Minneapolis Park and Recreation Board

Draft Southwest LRT DEIS Comment Letter

Current to: September 6, 2012

1 Cedar Lake Parkway-Grand Rounds

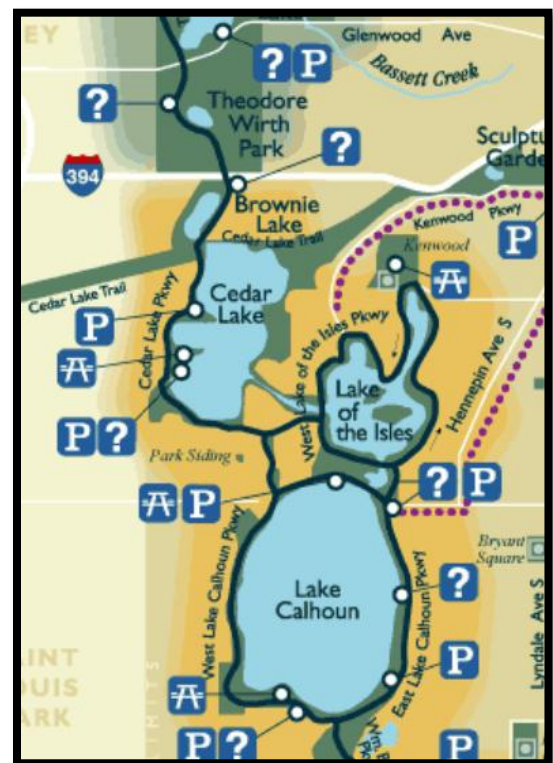
- Congestion and stoppages on the Grand Rounds caused by LRT/freight crossings violate MPRB policy regarding providing a continuous parkway system
- LRT/freight crossings and the resulting backups at this complex intersection directly conflict with heavy use of Grand Rounds by cars, bicyclists, and pedestrians

- Trail use and access will be disrupted along Cedar Lake and the Kenilworth Trail, as will connections to other MPRB trails
- Emergency vehicle access will be impeded to the Cedar Lake South Beach <++ verify that east to west is the normal or required direction of emergency vehicle access to the beach>
- +++ find a way to sub-number the outcomes.... **Outcome:** The integrity and intention of the Grand Rounds is maintained
- **Outcome:** Continuous, calm and safe flow of motorized and nonmotorized vehicles and pedestrians along the Grand Rounds and chain of lakes connecting trails

- Noise impacts from the LRT and at this intersection will reduce people’s enjoyment and use of the park and Grand Rounds
- Air pollution will increase substantially from many cars idling while waiting to cross the LRT line, and would harm users of the park, trails, Grand Rounds, and Cedar Lake South Beach
- **Outcome:** Noise levels will meet state and federal standards for park and trail users < special citations, although not necessary for typical/standard regs>
- **Outcome:** Air quality will meet state and federal standards for park and trail users, including any subsequent impact on water quality < special citations, although not necessary for typical/standard regs>
- **Outcome:** LRT and crossing-related noise will not diminish people’s enjoyment and use of the park, trails, Grand Rounds, and beach

- The views along the Grand Rounds and of Cedar Lake and parkland would be impeded by an at-grade LRT train, tracks, and power infrastructure
- **Outcome:** The view of and from Cedar Lake and surrounding parkland is preserved
- **Outcome:** The parkland around Cedar Lake remains the natural visual buffer between Cedar Lake and the Southwest LRT Corridor <How does this relate to MPRB and city plans?>

+++ how to tie this to issues or outcomes?? An LRT crossing that combines putting the LRT line in a depression and bridging the parkway address the majority of critical issues and meet most
